ADDENDUM NO. 2

Venetia Valley TK-8 School Landscape Renovations

Project Number #25-03

Addendum Date: March 20, 2025

ANLA JOB #: 2434

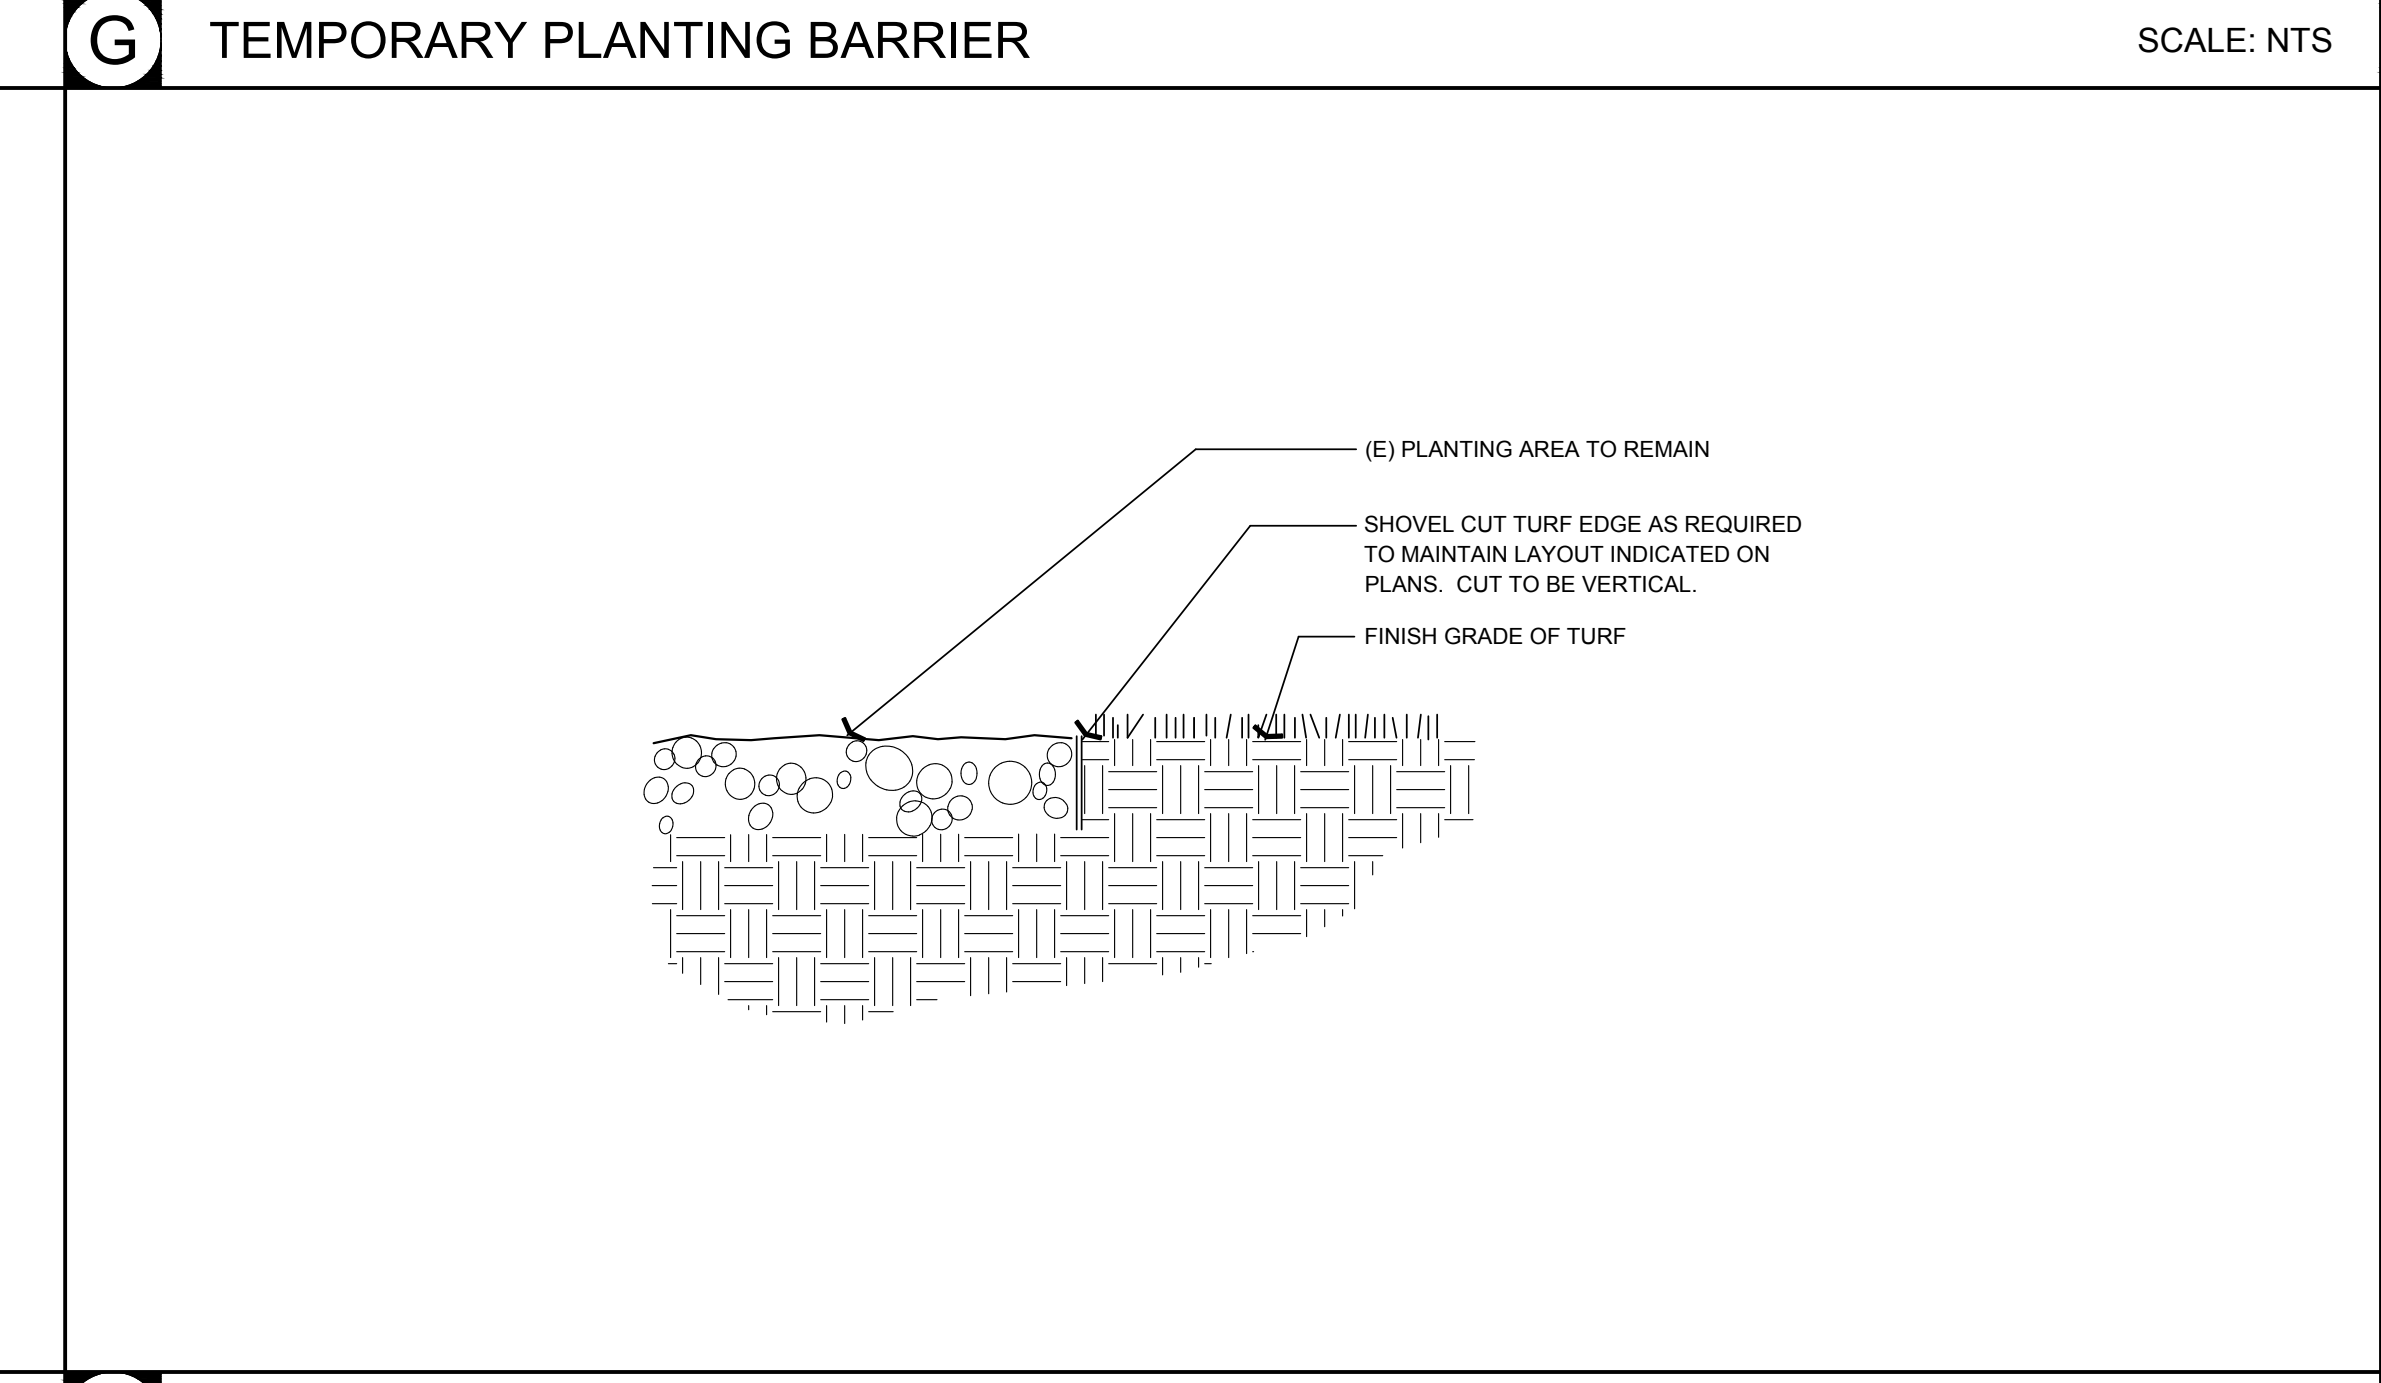
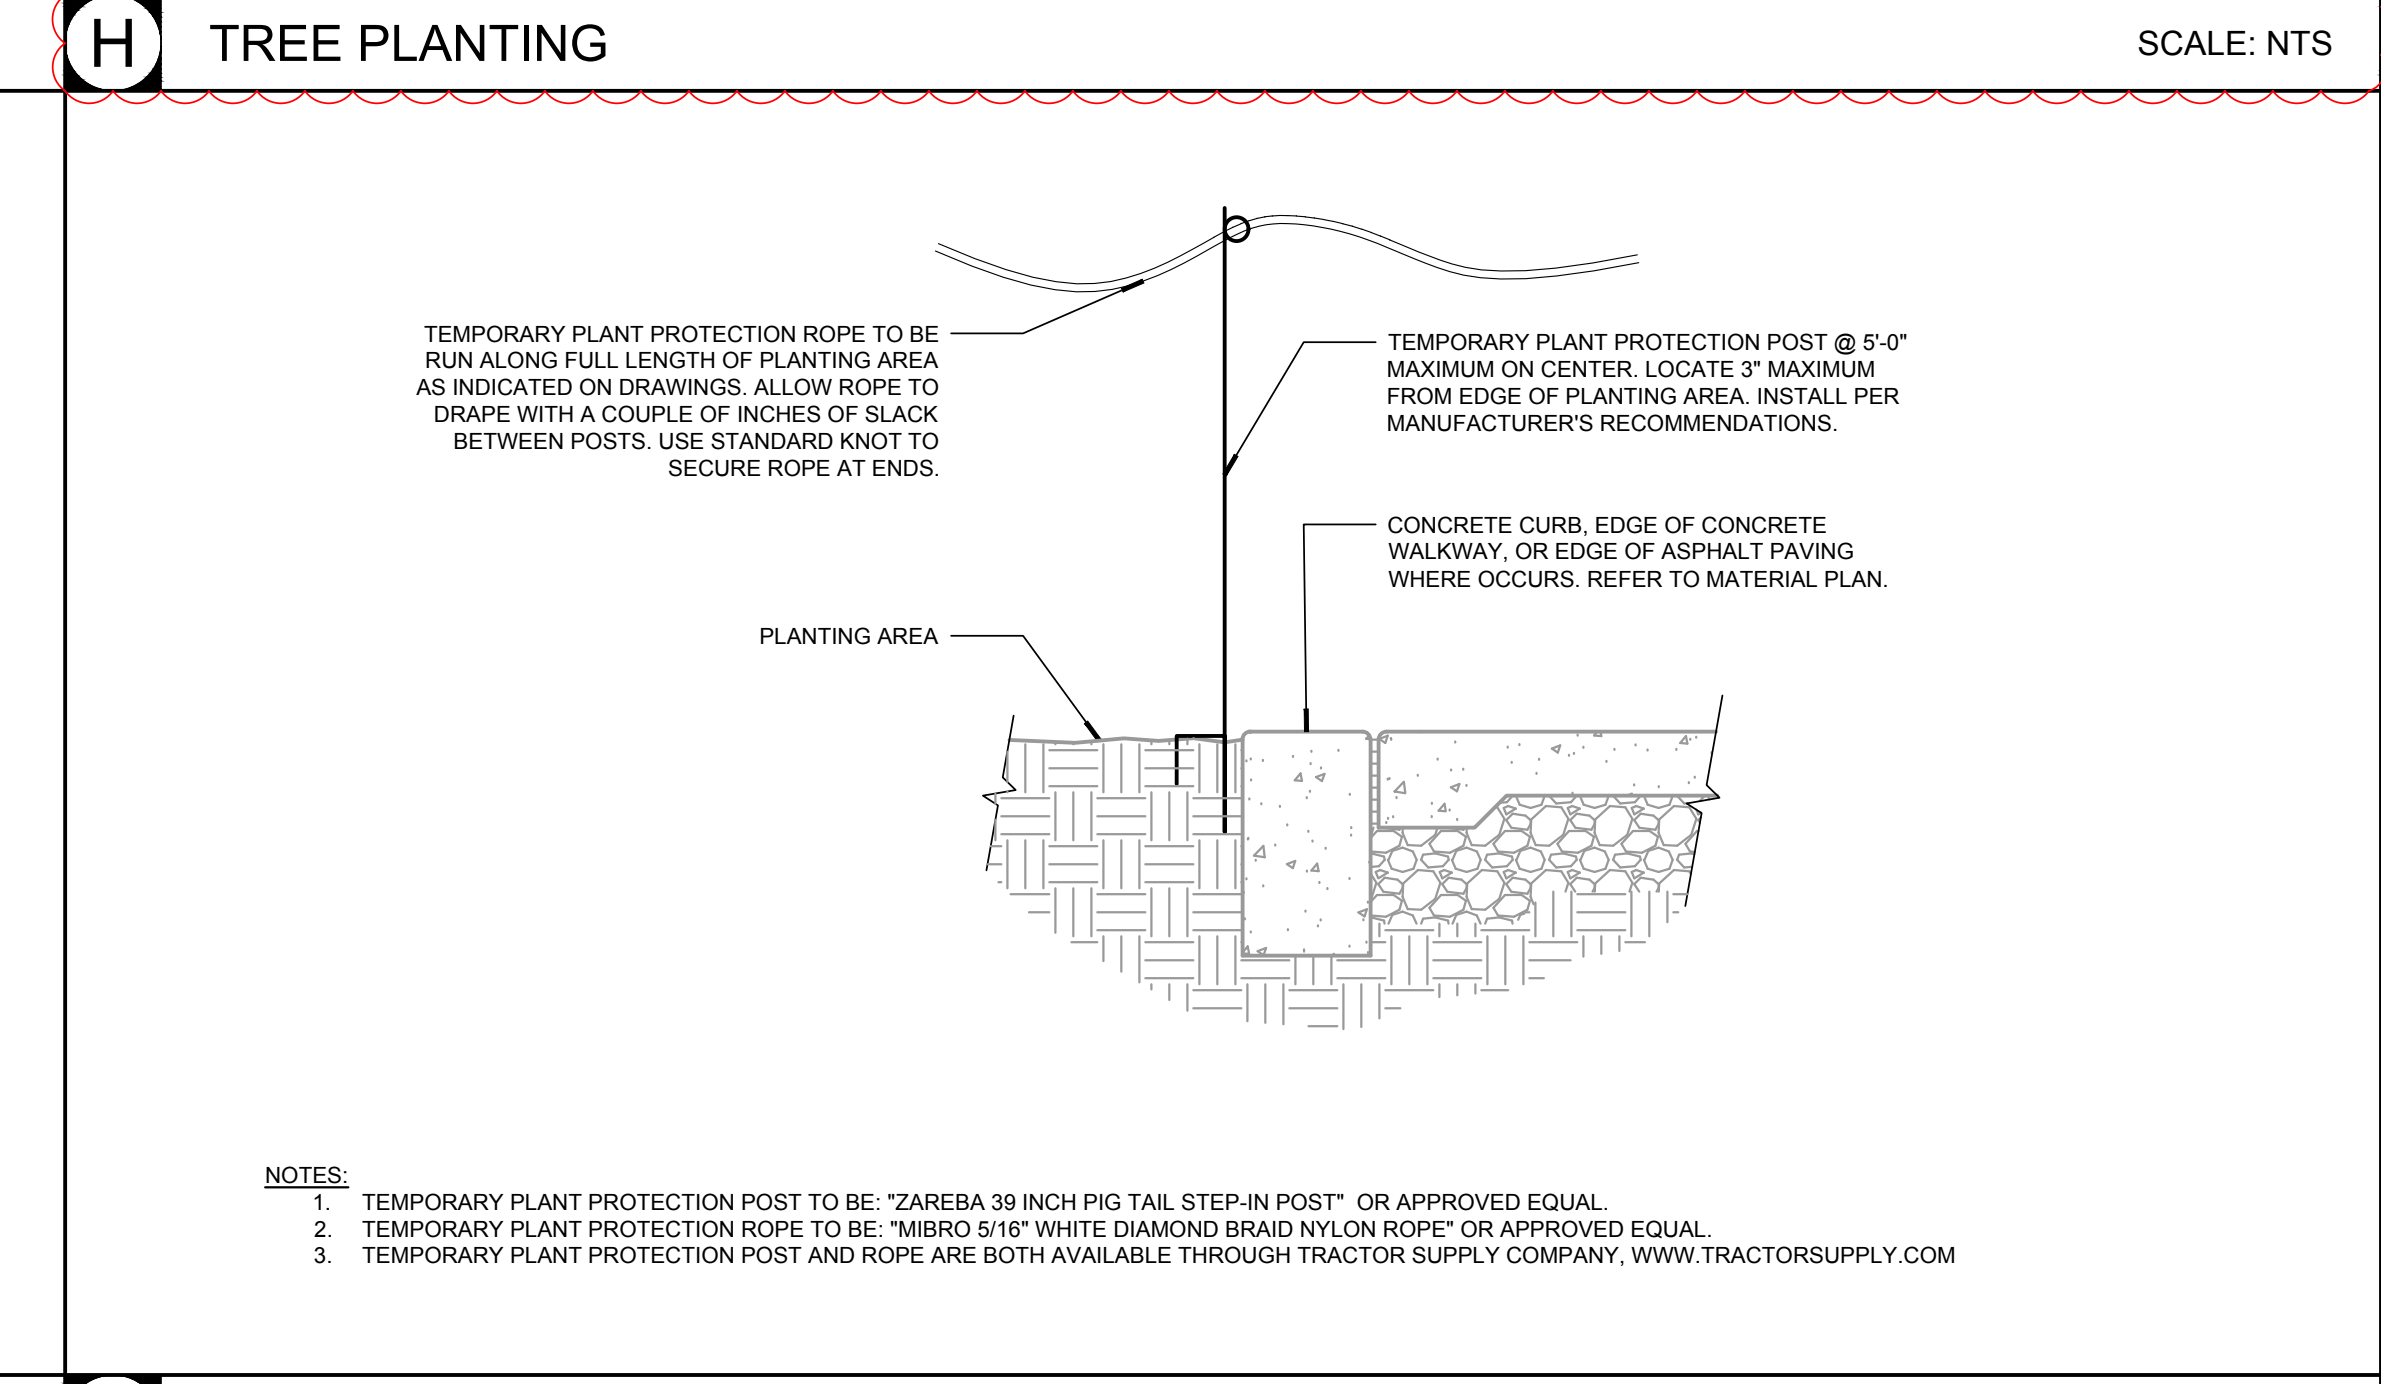
- a. Answer: Synthetic turf shall be Playground Grass ‘Quest’, a ForeverLawn product, available through Ross Recreation.
10. Question Received: **“Reference to sheet L3.2, rotor is 1-20-06-PRB-R-MPR, but this model is not available. Please confirm rotor is I-20-06-PRB-R-MPR.”**

18. Question Received: “Please confirm we can use existing wire for a new remote-control valve closed in building L1 middle school shown in sheet L3.2.”

19. Question Received: “Reference to sheet L3.08B, remote control valves closed to field area are H controller station but the call-out shows B controller station. Please clarify.”

ITEM NO. 1.5: SHEET L3.2 IRRIGATION PLAN:

Revise: Irrigation legend to include graphics for (E) SCH 40 PVC SLEEVES TO REMAIN.

Add: Callout to clarify location of (2) new irrigation lateral lines installed in sleeves that are to be installed via direct bore under existing paving to remain.

- a. Answer: Correct, rotor is to be I-20-06-PRB-R-MPR.
11. Question Received: **“Reference to sheet L1.1 in addendum #1, concrete paving shall be installed per detail C/L2.2, but detail C/L2.2 is asphalt paving. Please confirm concrete paving shall be bid as detail C/L2.1.”**

- a. Answer: Confirmed. The existing control wire for the valve adjacent to the middle school area is to be re-used.

- a. Answer: The 'H' or 'L' designations on the record drawings are in reference to the hydrozone type (H is for high water use, L is for low water use). All of the valves in the turf field areas function from Irrigation Controller 'B' as is labeled on sheet L3.2.

Replace: Sheet L3.2 in its entirety with the attached sheet Addendum 1-L3.2.
